FEBRUARY 12, 1992 FLOOD:
VENTURA BEACH RV RESORT

A SPECIAL REPORT
SUBMITTED BY FRIENDS OF THE VENTURA RIVER
TO THE
SAN BUENAVENTURA CITY COUNCIL

April 20, 1992

LCP Flood Mitigation Analysis

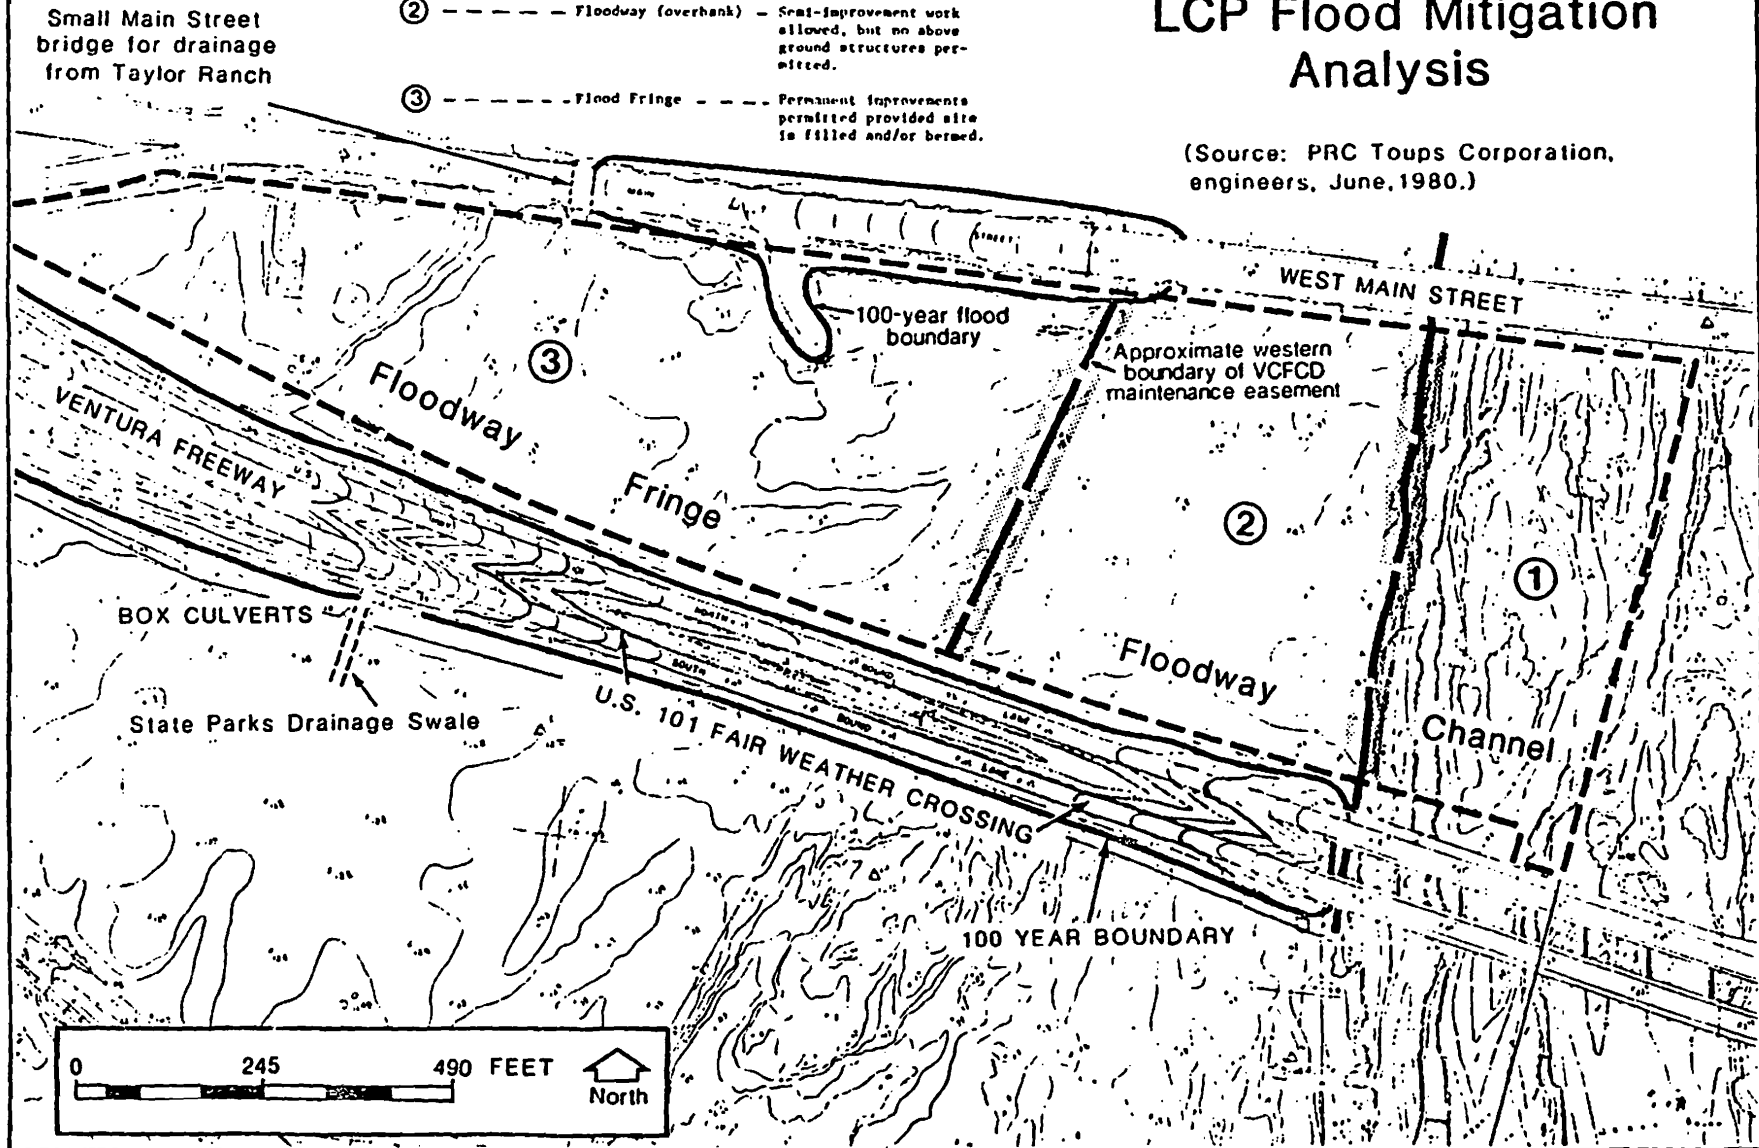
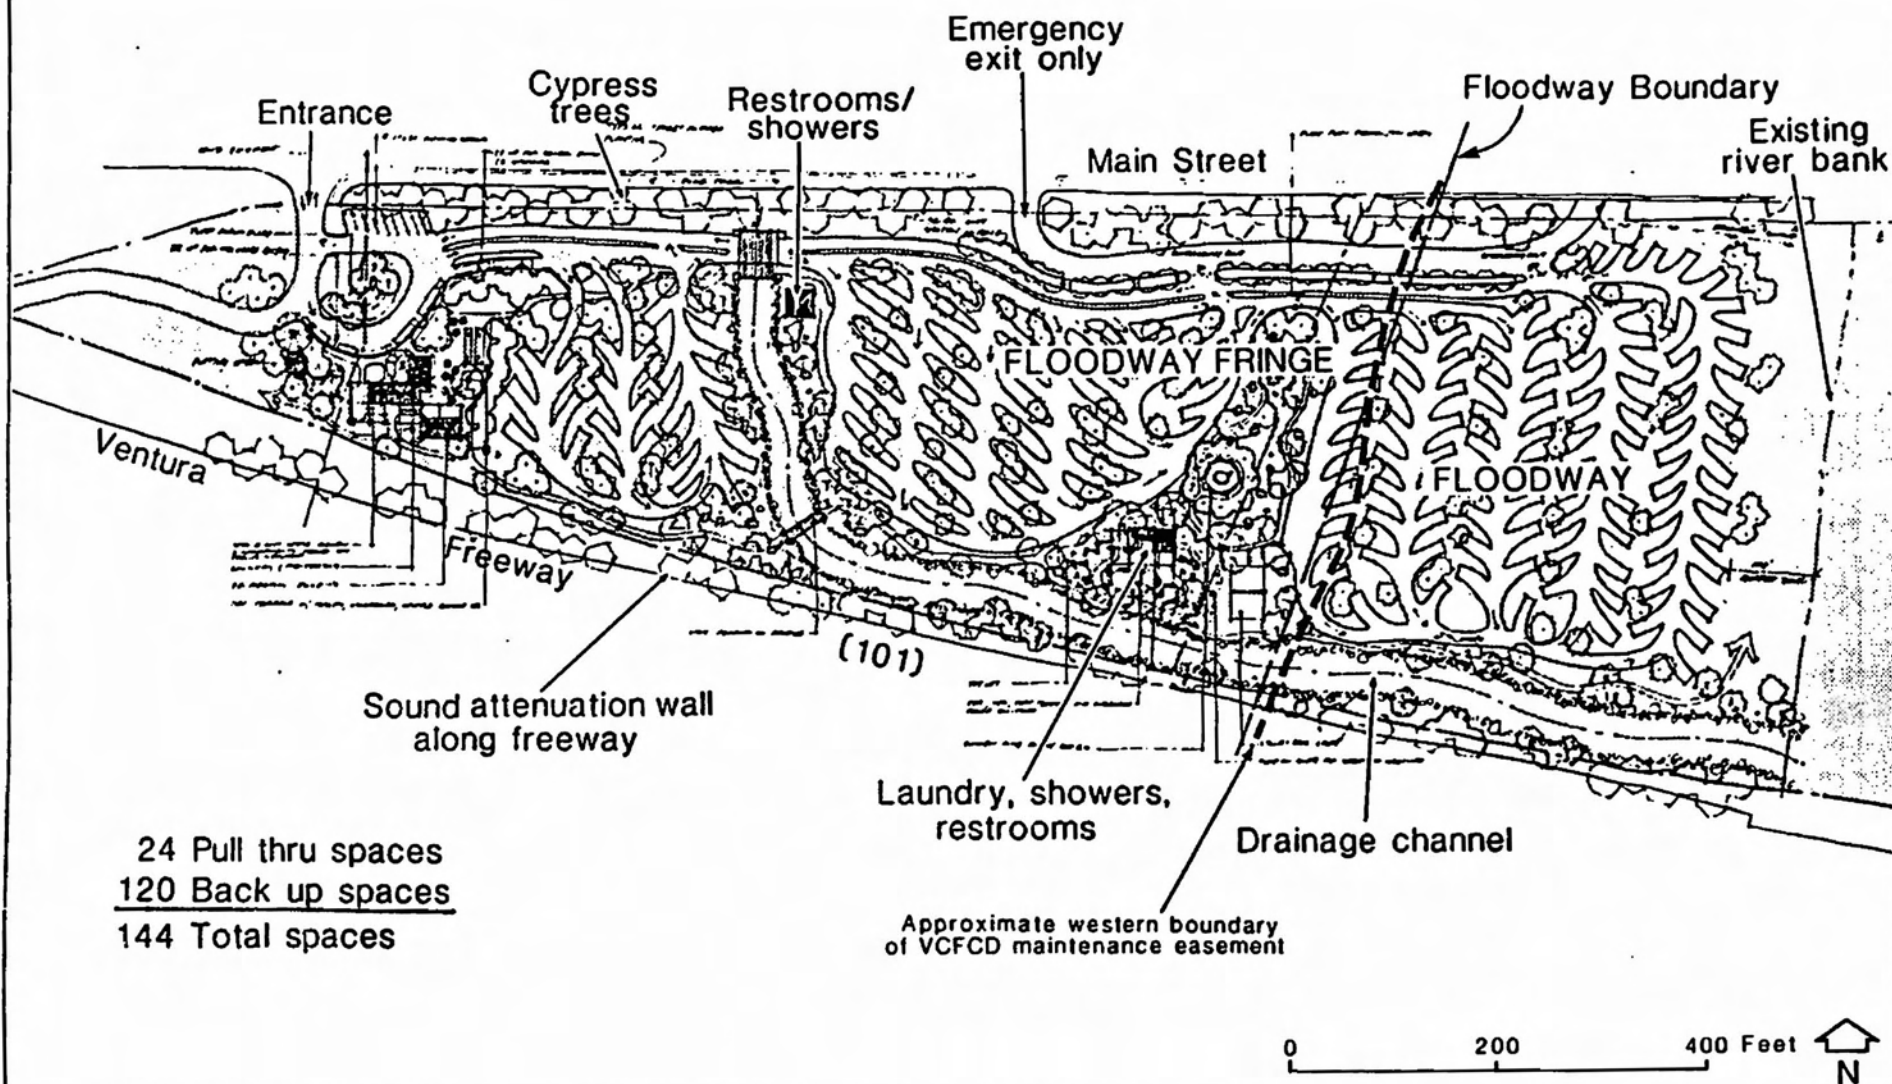
This model for predicting the areal extent of flooding under given magnitude of storm flows assumes a **fixed** cross-sectional channel area, and is not appropriate for watercourses with highly mobile channels and banks such as the Ventura River. It is particularly inappropriate for use on a delta where there are multiple channels. The inadequacy of the HEC-2 computer modeling was tragically demonstrated during the recent inundation of the the Ventura Beach RV Resort. The HEC-2 analysis in this instance predicted that the site would not be inundated in less than 78,000 cubic feet per second flows, but in fact was completely inundated with a 46,000 cubic feet per second flow.

The analysis misrepresented the nature of flooding patterns by misapplying the Federal Emergency Management Agency (FEMA) flood insurance terminology "floodway" and "floodway fringe" to the project site, using them for planning purposes for which they were not originally intended.

The term "floodway" is a technical term used by FEMA to designate a **lateral** area into which a discharge from a 100 year frequency storm can be squeezed without increasing the **vertical** height of the flood flow more than one (1) foot. Significantly, this term does not designate those areas which will be inundated **only** during a 100 year frequency storm. Similarly, the term "floodway fringe" is a technical term used to designate that portion of the natural 100 year flood plain which would be **theoretically** left dry after squeezing the 100 year flood flow into the "floodway". It does not designate that portion of the flood plain which is necessarily less prone to flooding.

Both of the terms are artificial in the sense that they do not purport to describe the **natural** pattern of flooding, but rather areas in which flood flows can be **artificially** channeled. They specifically were not intended to describe the pattern of flooding in either braided channels or on deltas with a system of distributary channels such as displayed by the Ventura River. Nevertheless both terms were used throughout the planning and decision making process to designate areas on the Ventura Beach RV Resort which would experience projected levels of flooding under uncontrolled conditions.

It must be emphasized that the "floodway fringe" areas are **not** necessarily less susceptible to flooding than "floodway areas: they are simply, and only theoretically, what is left of the flood plain for development without special flood insurance requirements when a 100 year frequently flood is squeezed laterally into the point where its vertical rise is no more than one (1) foot.
